FLORIDA POWER & LIGHT COMPANY
ST. LUCIE PLANT UNIT 2
EMERGENCY PROCEDURE NUMBER 2-0120043
REVISION 0

INADEQUATE CORE COOLING (ICC)
October 29, 1981

St. Lucie Plant
Unit No. 2 - 1978-890 MW Extension

SL-2 Round One Questions

FIGURE 440.67-1

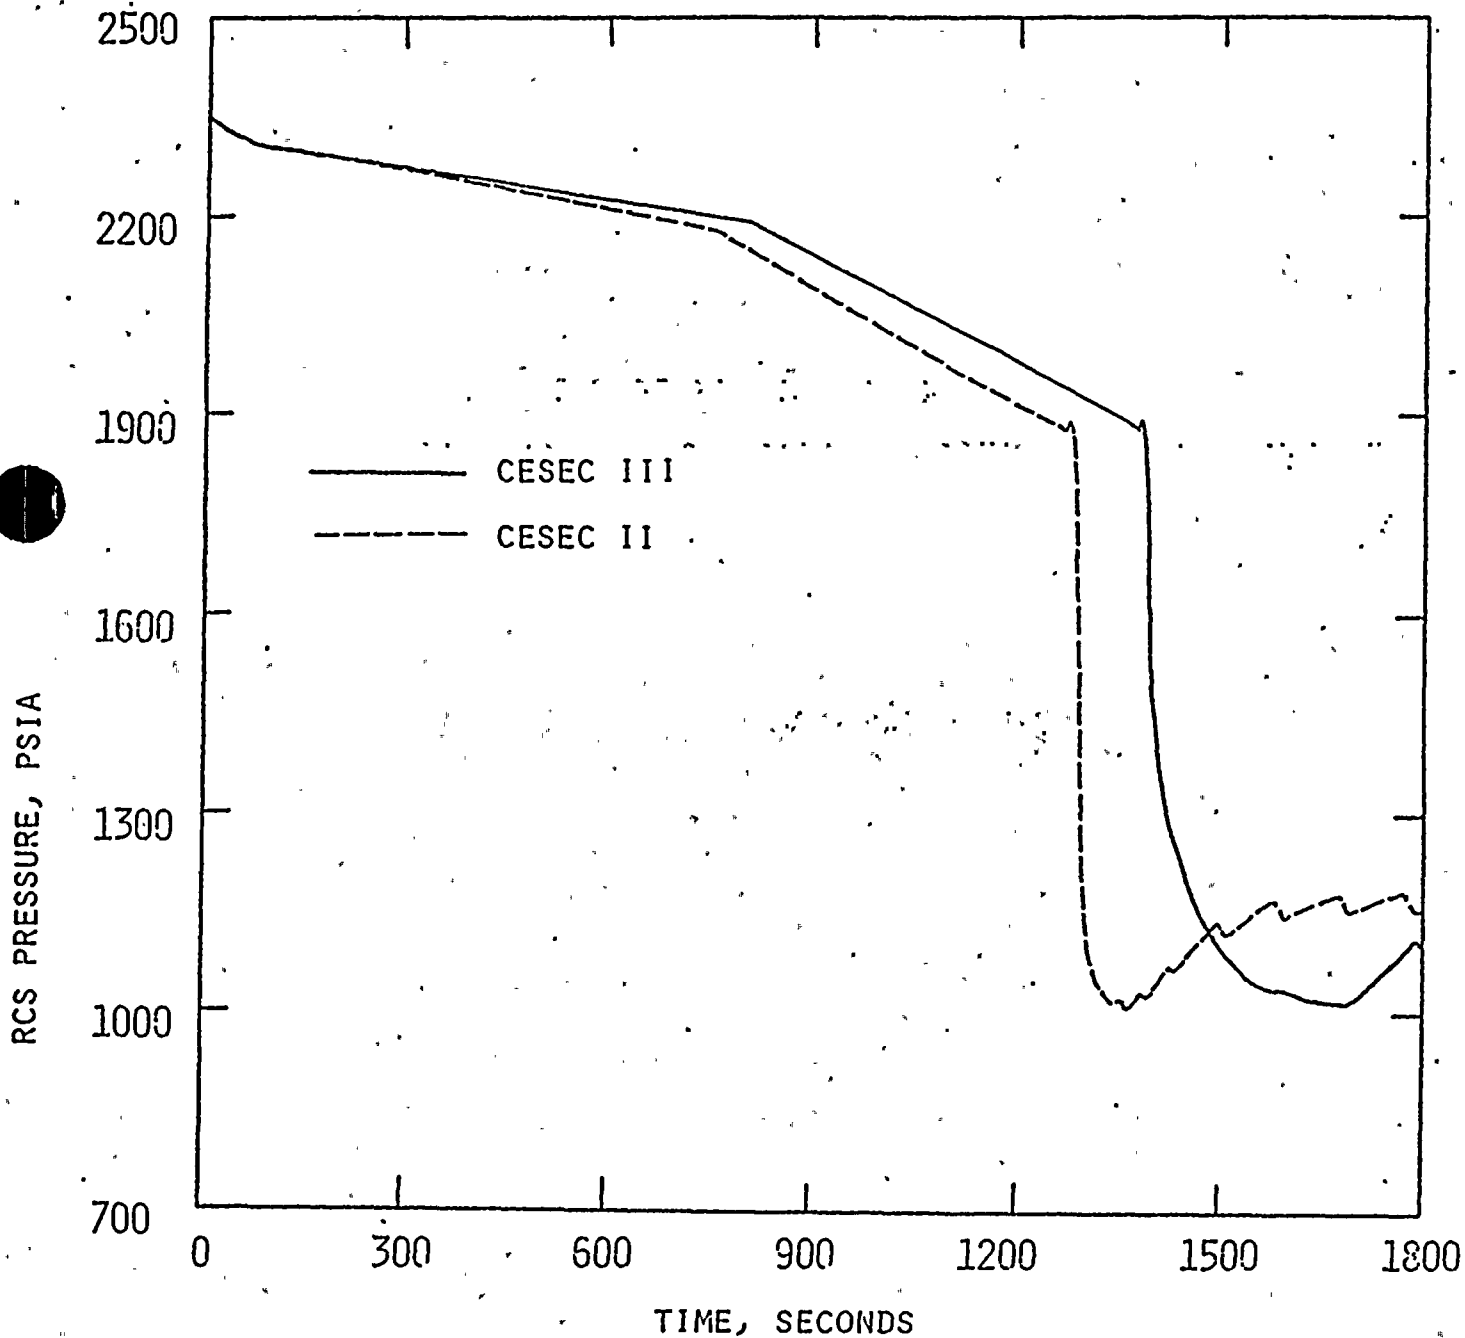
Figure 440.67-1 provides a comparison of pressurizer pressures predicted by the CESEC II and CESEC III codes. The effect of upper head voids on primary system pressure is illustrated in this figure. It shows similar trends for the RCS pressures during the transient. However, subsequent to reactor trip, the pressure predicted by the CESEC III code decreases at a lower rate than that predicted by the CESEC II code. This is due to the formation of voids in the upper head region, which controls the system pressure decay after the emptying of the pressurizer subsequent to reactor trip. The voids in this region are calculated to collapse at about 1700 seconds under the combined effect of charging flow, safety injection flow, reduced primary-to-secondary leak, and cooldown at the steam generators. The CESEC III code predicts refilling of the pressurizer and repressurization of the RCS as a result of the net mass influx into the RCS, subsequent to collapse of the upper head voids. The CESEC II code predicts refilling of the pressurizer and RCS repressurization much earlier than CESEC III, since it does not explicitly account for upper head void formation and collapse.

FIGURE 440.67-2
STEAM GENERATOR TUBE RUPTURE FOR ST. LUCIE 2 WITHOUT LOSS OF
OFFSITE POWER - VOID FORMATION IN TOP OF REACTOR VESSEL

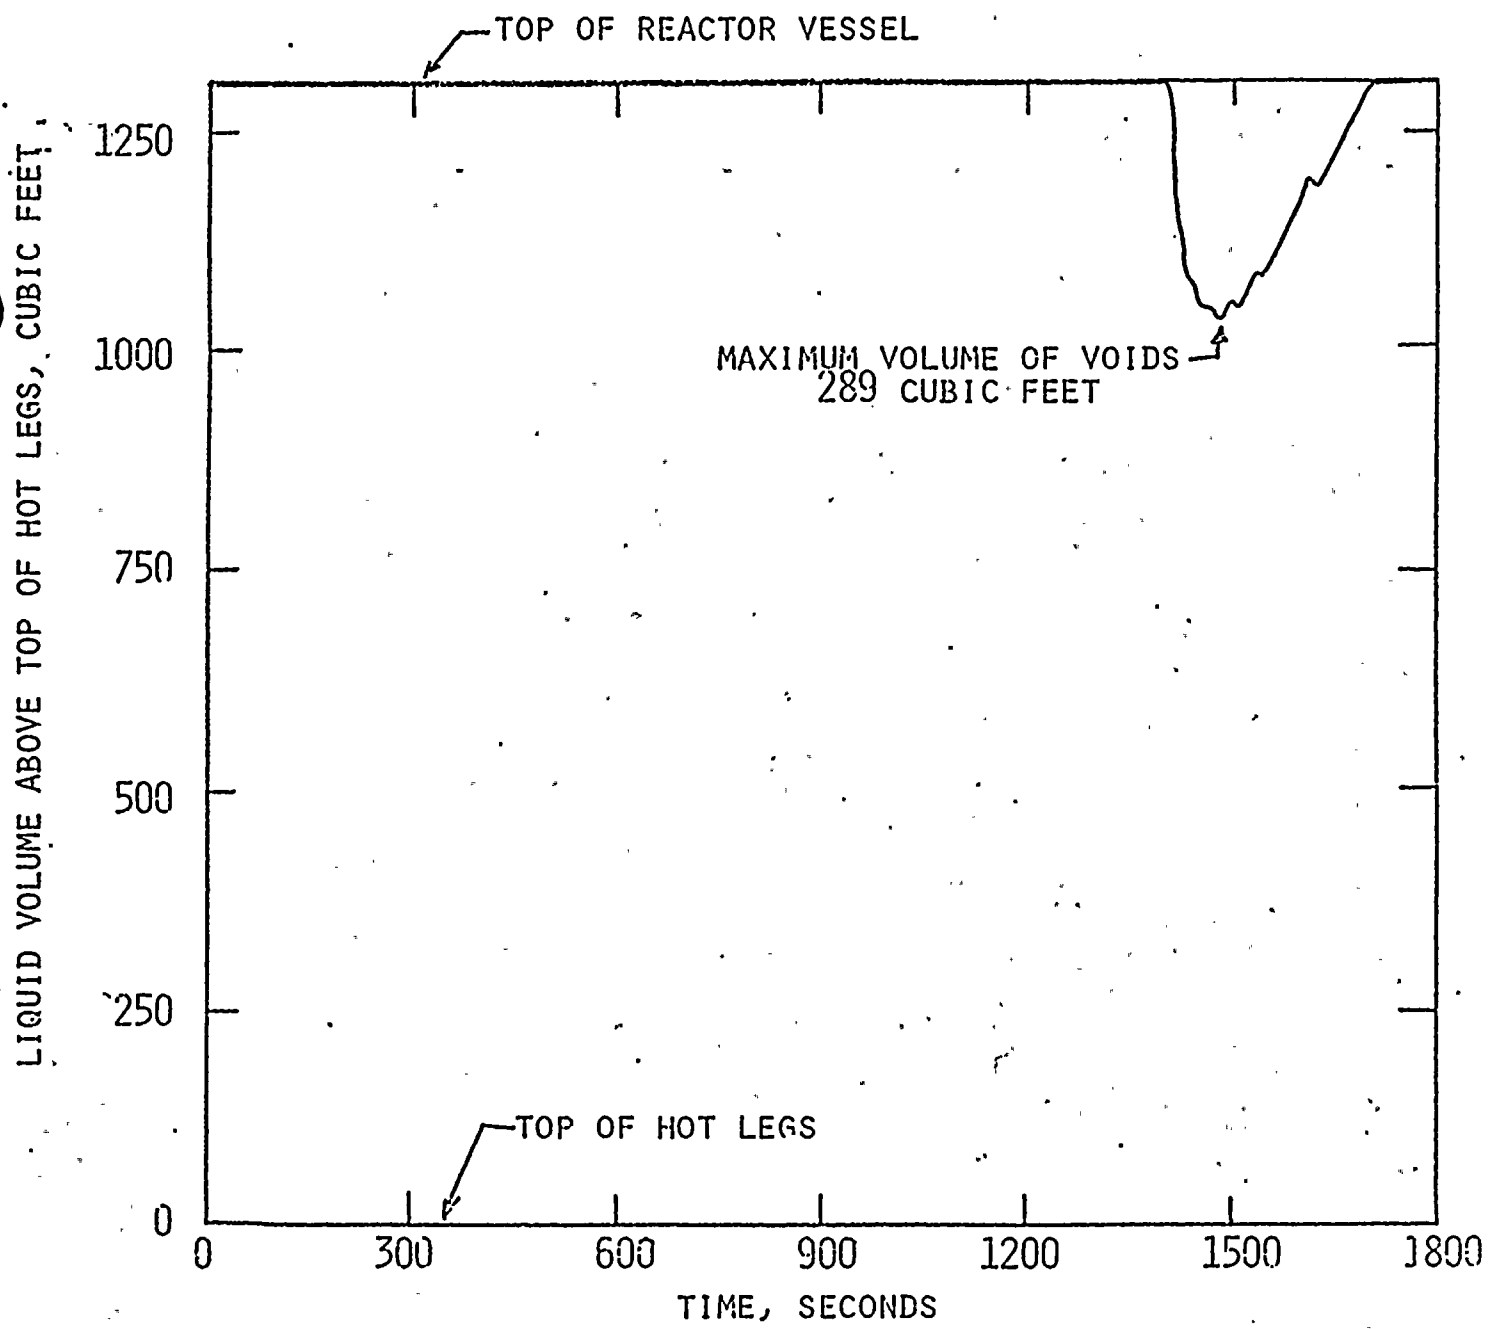
Figure 440.67-2 shows the behavior of the liquid volume in the reactor vessel above the top of the hot legs for the CESEC III analysis. The amount of voids predicted is not large enough to expand the steam bubble beyond the upper head region and to the elevation of the hot legs.

FP&L	DISCHARGE ENTHALPY vs STEAM GENERATOR LIQUID INVENTORY	Figure 440.81 (
------	--	-----------------

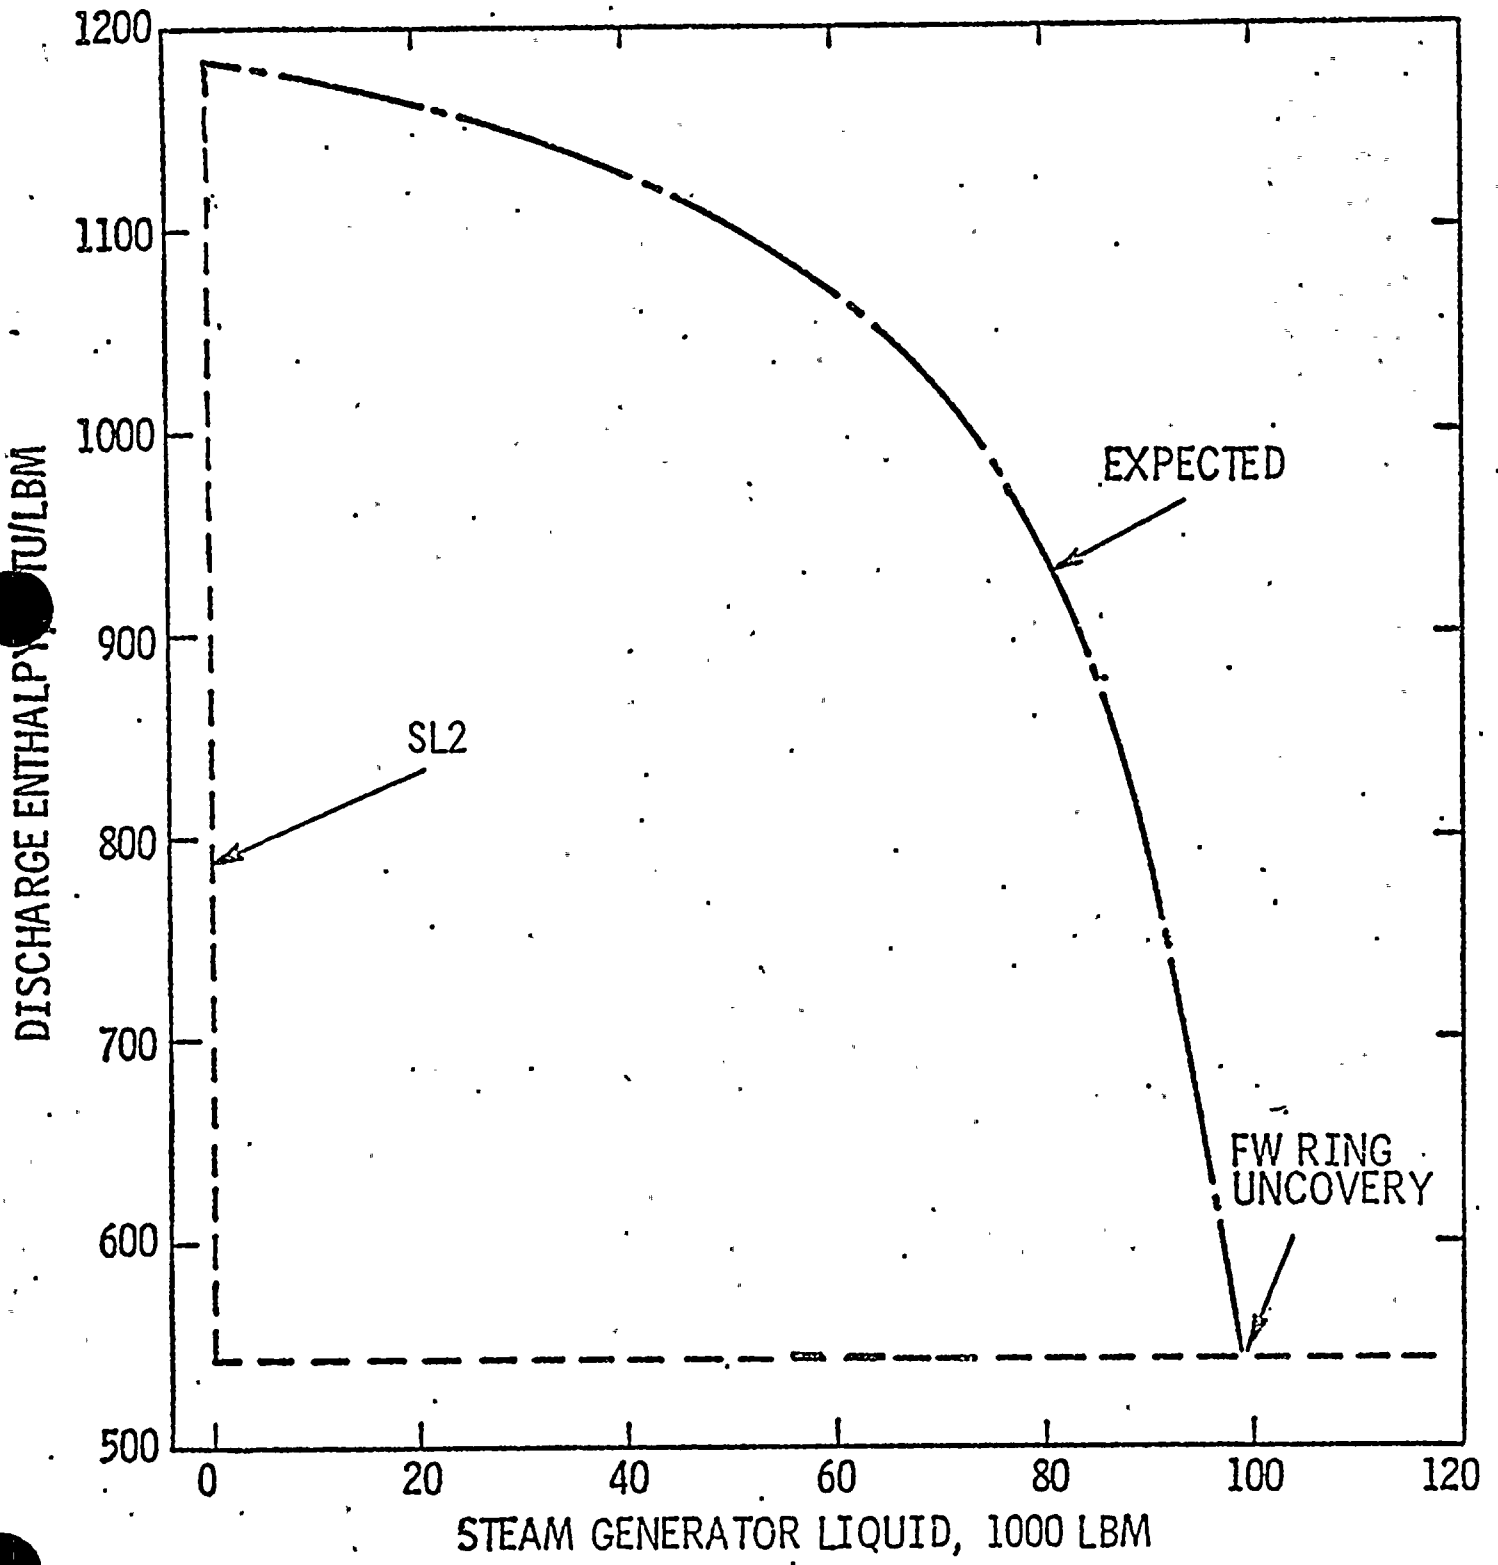
The enthalpy of the fluid discharged from the feedline break partially determines the heat removal capability of the affected steam generator. Minimizing the discharge enthalpy reduces the heat removal and, thereby maximizes the RCS pressurization. The model for SL-2 was biased to conservatively under-estimate the discharge enthalpy. Figure 440.81.f-2 shows the behavior of the discharge enthalpy during steam generator dryout predicted by the SL-2 method, along with the expected behavior.

The expected enthalpy response for SL-2 can be understood by considering relatively high location of the feedwater nozzle and distribution ring on the steam generator. Fluid discharge from a feedline break is drawn from the downcomer section through the feedwater distribution ring. Saturated liquid in the downcomer normally covers the feedwater ring. During FWLB the downcomer liquid will be depleted lowering the water level and uncovering the ring. A two phase fluid (high enthalpy) will be discharged thereafter. Feedwater ring uncover and the associated high enthalpy will occur before the steam generator liquid inventory decreased below 100,000 lbm.
